Vermont Yankee Nuclear Power Station

Proposed Technical Specification Change No. 263

Extended Power Uprate – Supplement No. 8

Response to Request for Additional Information

**Figure EMCB-A-1-1**  
**Schematic Representation of Drain Channel Cracking**

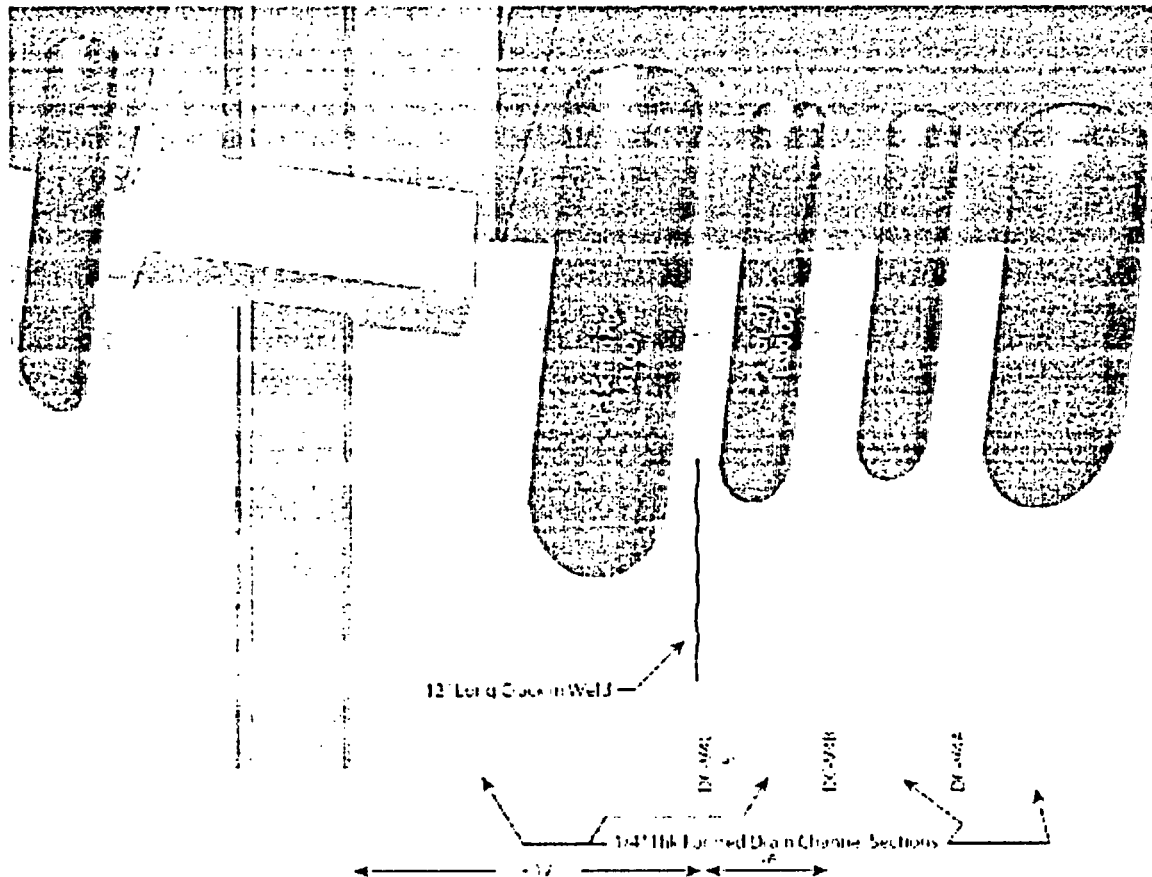
For the case of the VYNPS dryer drain channel cracking, the inspection evaluation (discussed further in the RAI response EMCB-B-2) established that this crack is IGSCC with no evidence of fatigue extension at current licensed thermal power operating condition. It is located in the heat-affected-zone adjacent to the weld and follows the grain boundaries, exhibiting a jagged appearance. The crack is not straight and does not have any characteristics of a fatigue crack. Figure EMCB-A-1-1 schematically shows the length and location of the 12 inch IGSCC crack. The initial engineering assessment dispositioned the flaw based on qualitative factors: (1) the drain channel flaw is in the non-structural portion of the dryer (i.e., they are not located in the skirt structure itself), (2) the drain channel flaw is only 13% of the length of the weld, (3) there is a lack of any field experience of drain channel cracking extending the entire length of the weld and (4) a postulated full length crack extending the full length of the weld if postulated to propagate by fatigue during future operation, would still not generate a loose piece. Two sides of the skirt plate and the pipe attachment provide enough structure to maintain integrity of the cracked location. The field experience supports the as-is operation decision, particularly in the context that the indication will be re-inspected at the next outage. However, in order to address the request for a structural analysis, the IGSCC flaw was also assessed quantitatively.

**Figure EMCB-A-1-2**  
**Cut-away of Bank Showing Unit End Plate**

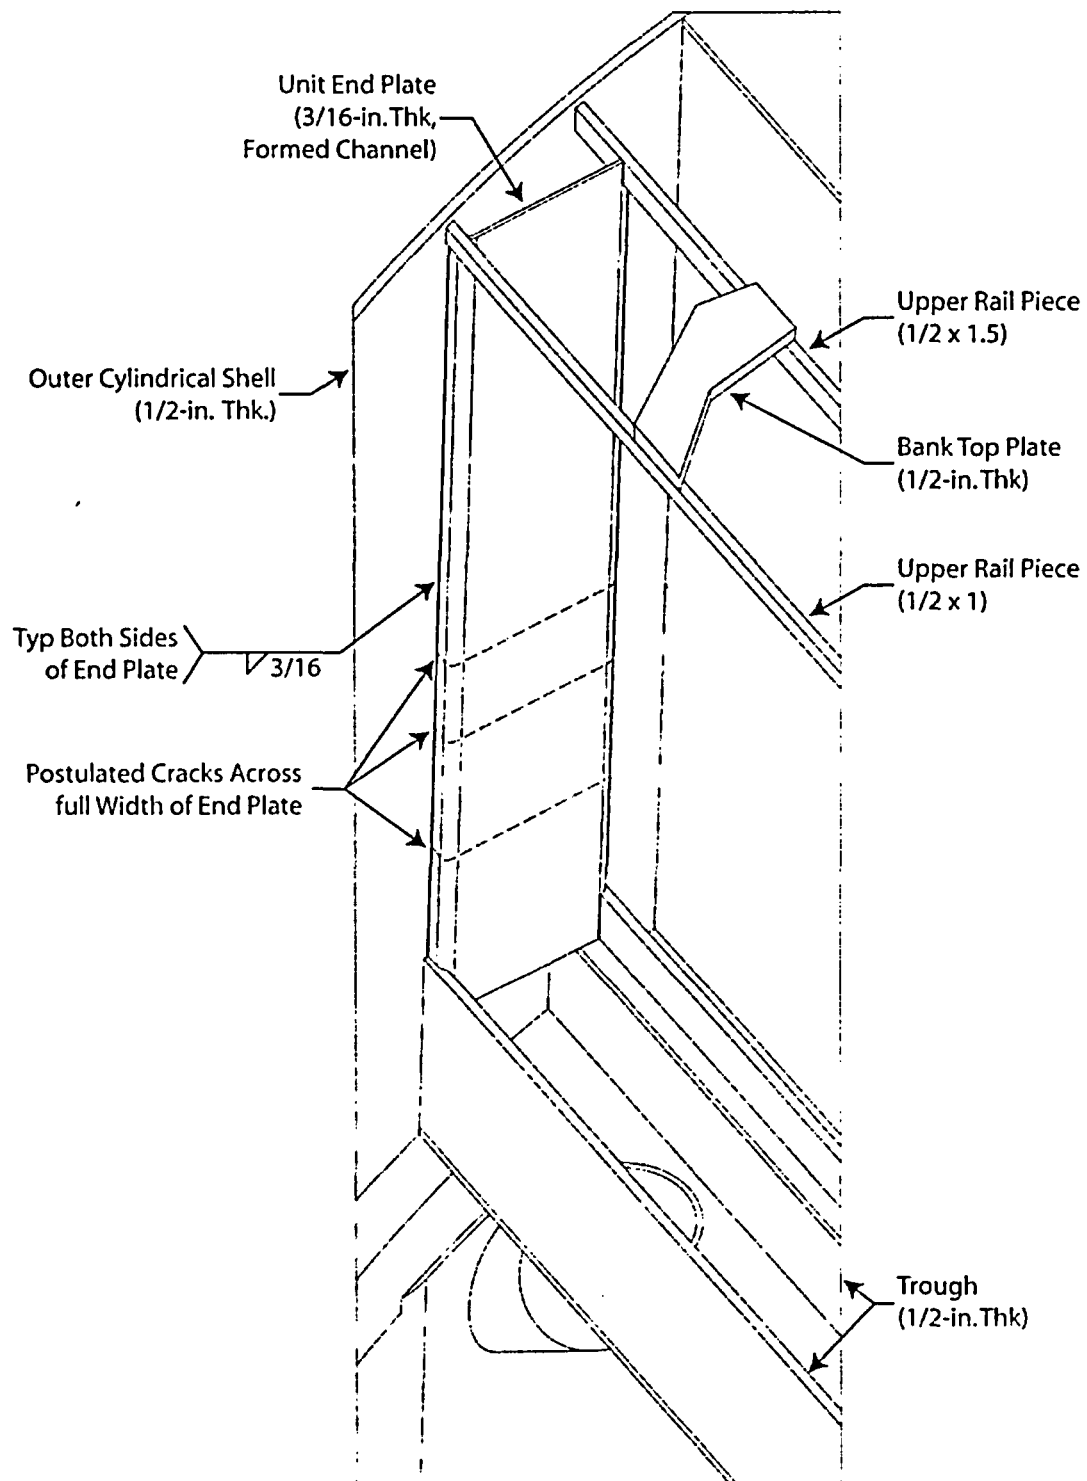
The dryer unit end plates, with indications, are securely attached and captured within the structure of the steam dryer bank assembly. The vertical edges of these end plates are attached to the dryer assembly with 3/16-inch fillet welds (each weld approximately 48-inches long). There were no relevant indications reported in these vertical welds. The geometric configuration of unit end plates is such that the upper and lower edges are mechanically captured by the steam dryer assembly as shown in Figure EMCB-A-1-2. The reported horizontal indications were seen in the 1.25-inch inlet side end plate flange. The vanes prevent inspection of the central end plate surface, but inspection of the outlet side end plate flanges found no indications. For the purpose of this discussion it is postulated that the end plate horizontal indications propagate across the entire 8.75-inch unit end plate width including both the inlet and outlet side flange, as shown in Figure EMCB-A-1-2. Such full width through thickness cracks would have no structural impact nor is there any concern for loose parts. The separated end plate sections, as shown in Figure EMCB-A-1-2, are still attached and will continue to function.

Figure EMEB-B-2-1  
VYR24-04-01 Indication Locations

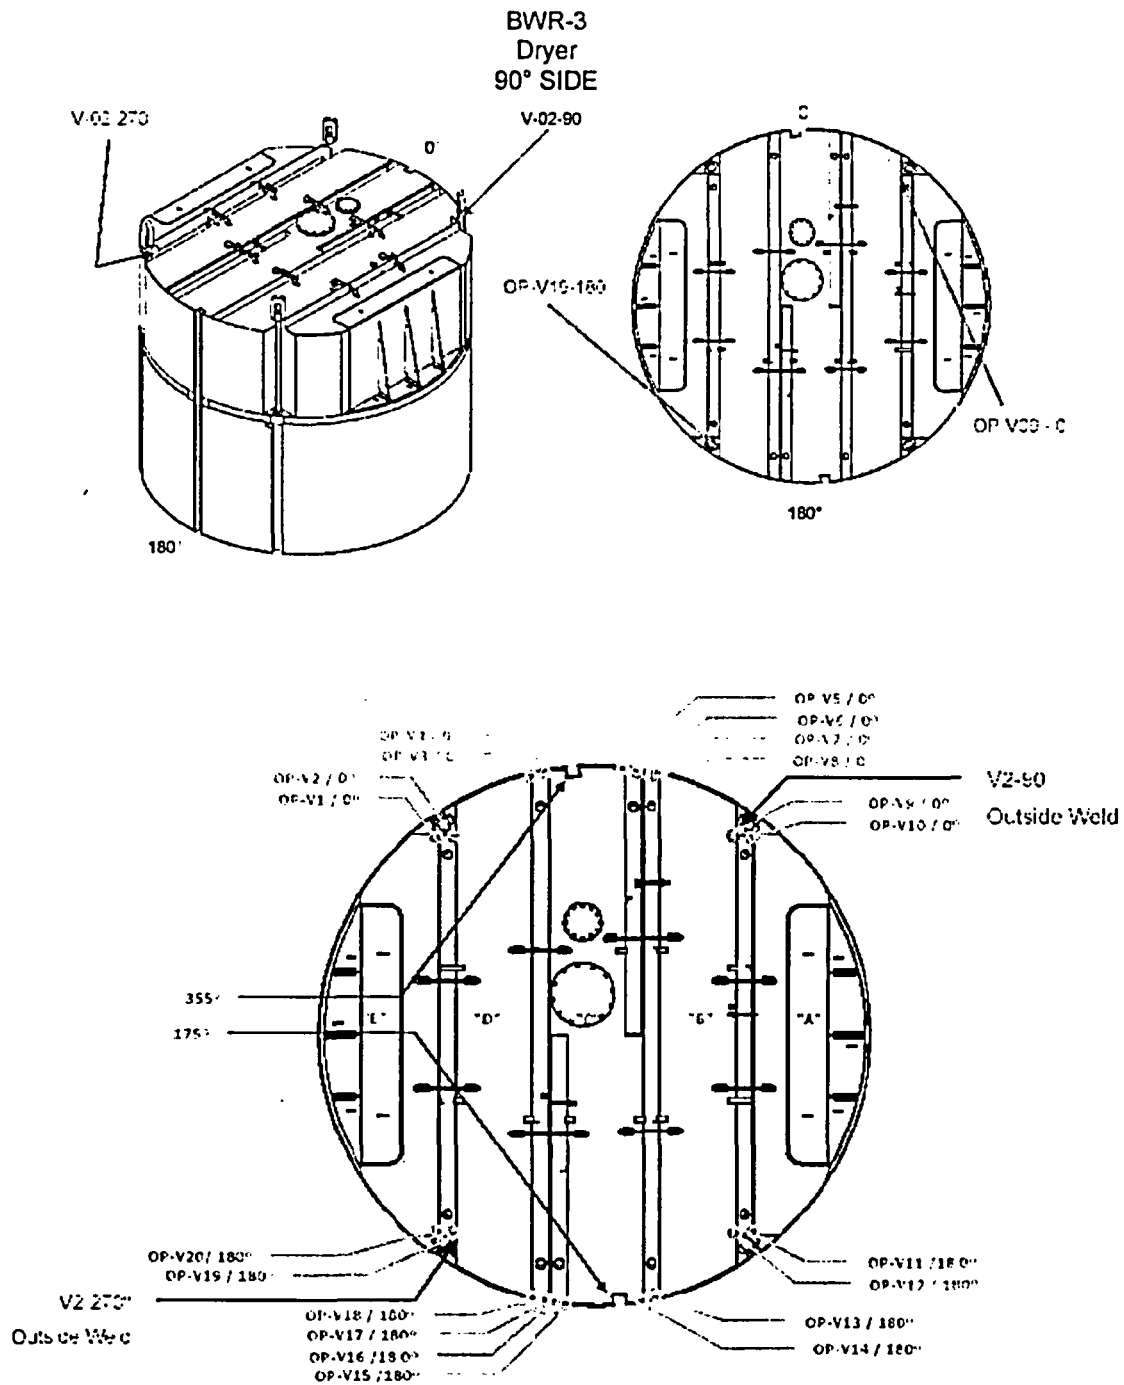
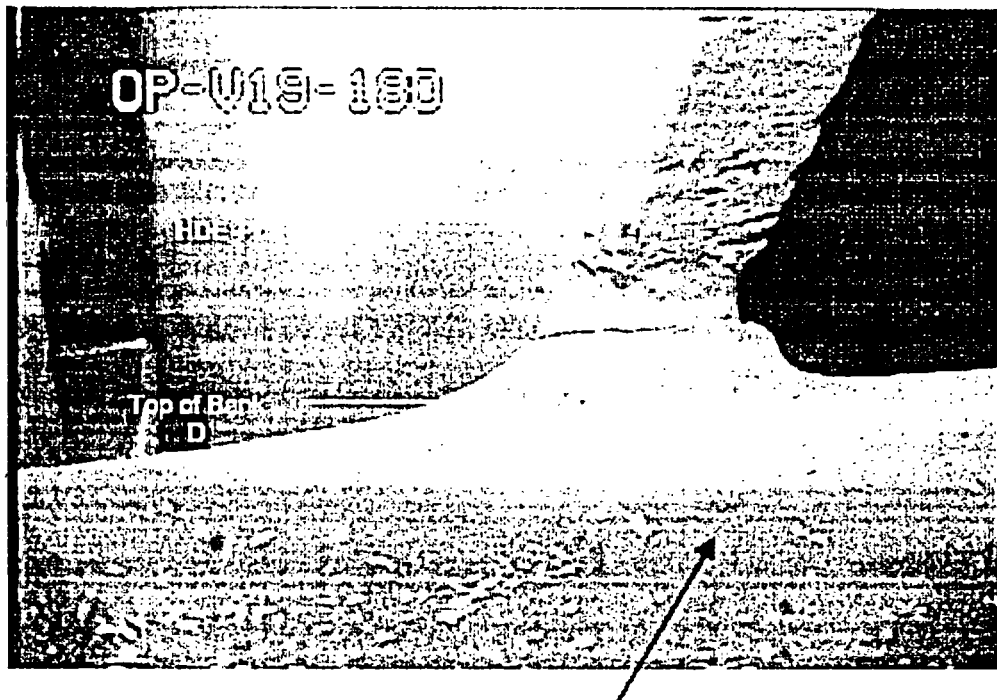
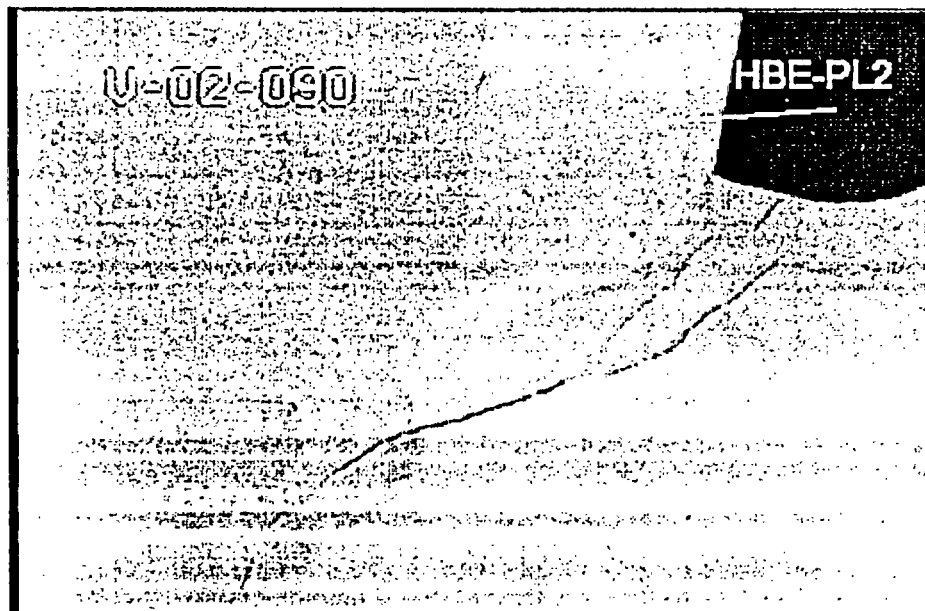
Indications were found at diametrically opposed locations on the exterior steam dam. Figure EMEB-B-2-1 is a schematic of the locations with respect to the overall dryer.

Figure EMEB-B-2-2  
Inspection Photographs of 215-degree Azimuth Indication

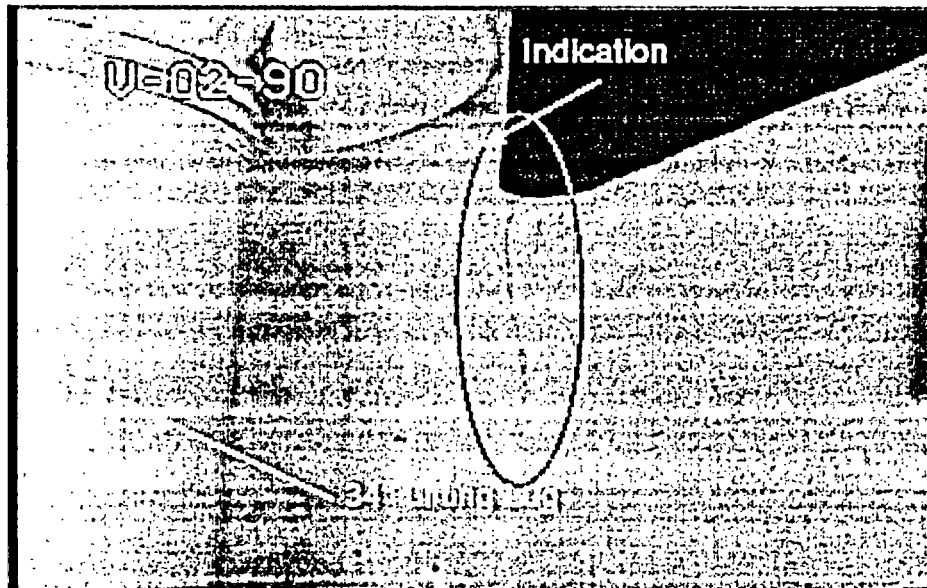
The first indication was found in welds OP-V19-180 and V02-270. These welds are located at the 215-degree azimuth of the dryer, behind lifting lug "C". Figure EMEB-B-2-2 shows the indication along the top region of the fillet welds joining plate HDE-PL3 and dryer Bank "D". The indication started near the top of V02-270, continued over the top and around the end of the HDE-PL3 plate and proceeded into weld OP-V19-180. The total length of the indication was approximately 3-inches long.

Figure EMEB-B-2-4  
VYR24-04-01 Crack Grind Out and Weld Repair

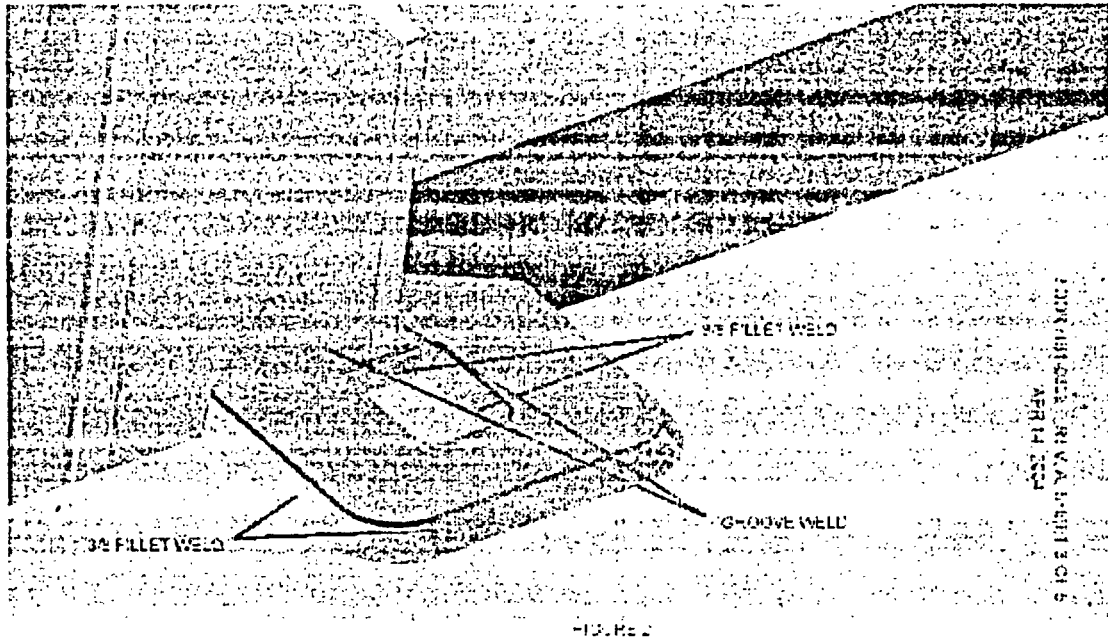
The repair of the cracked locations consisted of grinding out the locations to one inch beyond the crack tip and reapplying a  $\frac{1}{2}$  - weld. The grind out of the crack and weld repair at the V02-90 location is shown in Figure EMEB-B-2-4. In addition, a repair fixture was installed at both the observed crack locations (35-degree and 215-degree azimuths) and the structurally identical locations (144 degrees and 324 degrees) to provide additional confidence that no additional cracking will occur at these locations during operation at CPPU conditions. Each repair fixture was welded between dryer band top hood and the steam dam plate where the cracks were observed.
